Application for Waiver from Construction Standards for Public Water Systems

Water System Name Portland Water Bureau PWS ID 00657
Project or Facility Cottrell Road Transmission Main County Multnomah
Need for waiver identified: Water System Survey Date of Survey
 Plan Review # Exempt

Construction standard requested to be waived: OAR 333-061-0050 (9)(b) water sewer separation

Bull Run Filtration Pipelines
COTTRELL RD TRANSMISSION
PLAN AND PROFILE
STA 28+00 TO 31+50

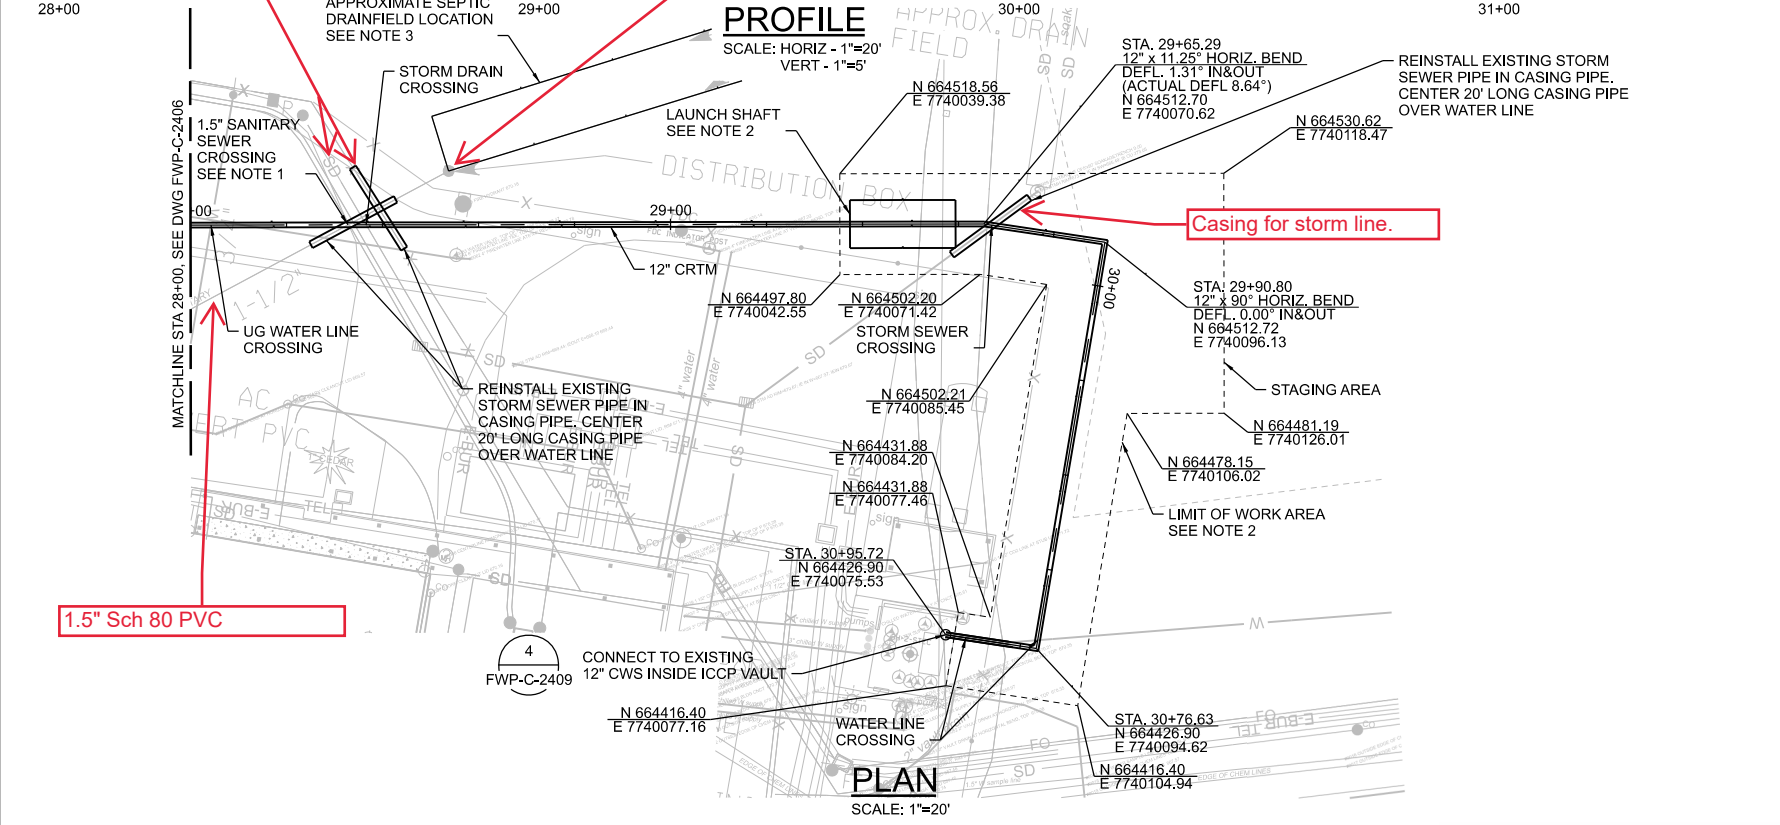
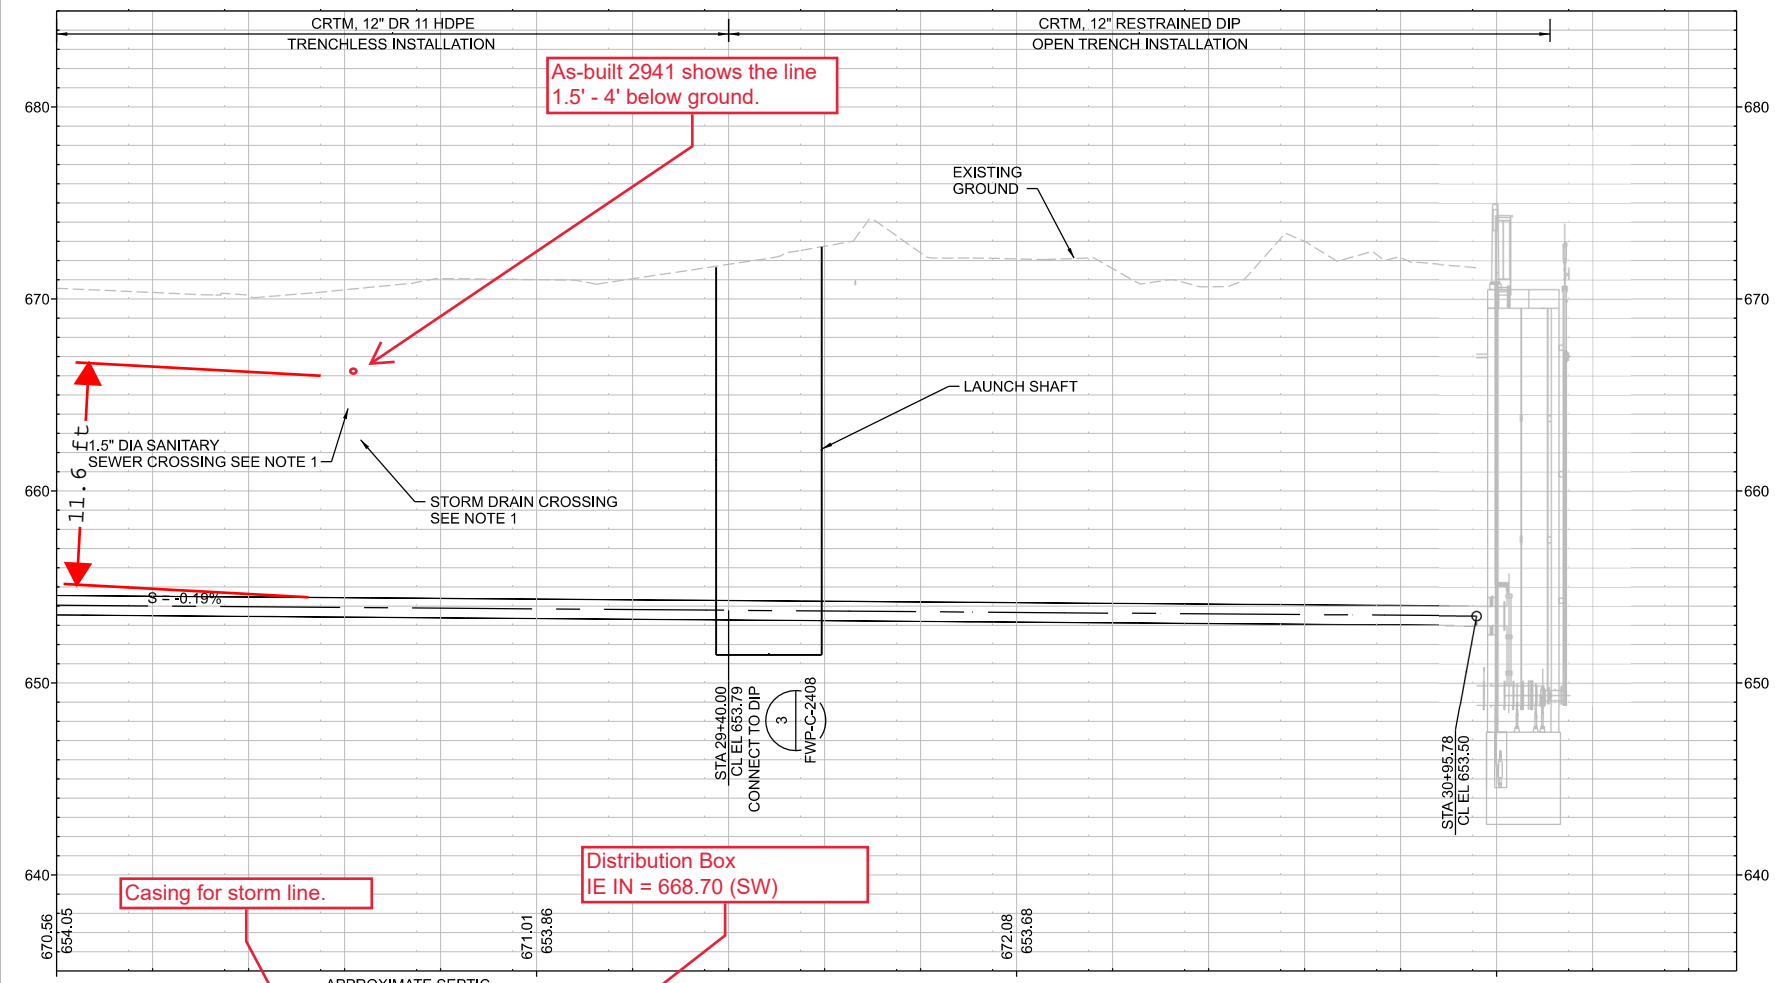
Describe situation that conflicts with the standard. A proposed 12-inch water line will cross perpendicularly underneath an existing 1.5-inch sewer service at 28+60. There is 11-feet of vertical separation between them.

The proposed 12" transmission main will be placed below an existing sanitary line at a crossing. Oregon Administrative Rules require that new water mains be placed 1.5' over sanitary lines at crossings.

The current proposal is described in CRTM (Backfeed Line) Alignment Revision Technical Memo dated 9/28/22. It shows a trenchless installation of 12" HDPE under the existing sanitary line at an approximate depth of 15'. Vertical separation between the water and sanitary line would be approximately 11'. The HDPE would be a continuous line from entry and receiving shaft therefore the connections with the 12" HDPE would be located at least 100' from the sanitary line.

Describe proposed alternate measure that provide adequate protection to public health and safety. OAR 333-061-0050(9)(b)(C) allows for a waterline to be installed underneath an existing sewer under certain conditions. First, the soil between the pipes must be thoroughly tamped to prevent settlement of the sewer. For this project, the water line will be installed via directional drilling, so the 11-feet of soil between the pipes will not be disturbed. The natural degree of compaction of the soil will be maintained, providing equivalent protection to tamping construction material. Second, one length of water pipe must be centered at the crossing. For this project, continuous HDPE pipe will be used so that there are no water line joints along the entire length of pipe and certainly none within 10-feet on either side of the sewer crossing. Third, the sewer pipe must be inspected and if in poor condition mitigation taken. In an abundance of caution, for this project it will be assumed that the sewer pipe is in poor condition. A 20-foot

sleeve will be installed centered over the water crossing. This is equivalent to replacing the sewer or encasing in concrete for 10-feet on either side of the crossing.

Plan Review Coordinator's notes: Proposed alternate measures appear to provide adequate protection to public health and safety.

Continuous HDPE piping installed using trenchless Horizontal Directional Drilling (HDD) with more than 10' vertical skin-to-skin clearance from the sanitary line.

Casing of the sanitary line is shown on the current design plans if the mitigation is deemed necessary during this review. The casing is proposed to be a continuous 20' long pipe centered over the sanitary line.
